## S5000 TECHNICAL BULLETIN

Date	18/05/22
Topic	Steering Rack Clamp Bolt
Priority	High

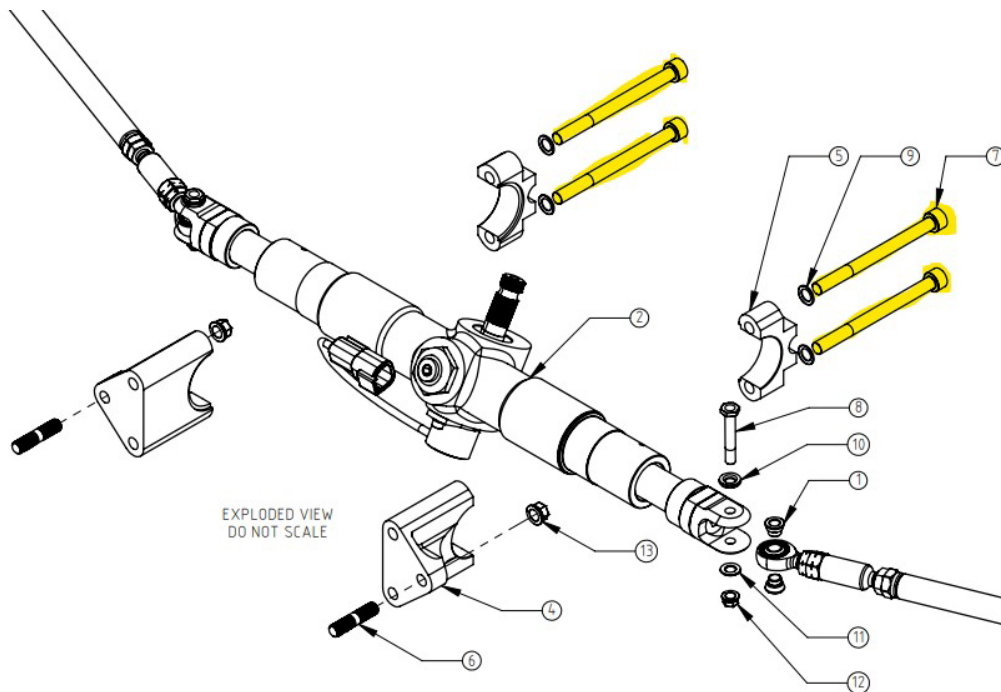
At the AGP in R3 we had a steering rack mount bolt strip the thread in the chassis bulkhead insert causing the rack to come loose and the car to DNF the race.

Upon inspection it was found that the 4x bolts (item 7, highlighted yellow below) were M8 SHCS 90mm Long with insufficient thread engagement.

Ensure M8 SHCS 100mm Long bolts are used in this application. Check all cars and replace if needed.
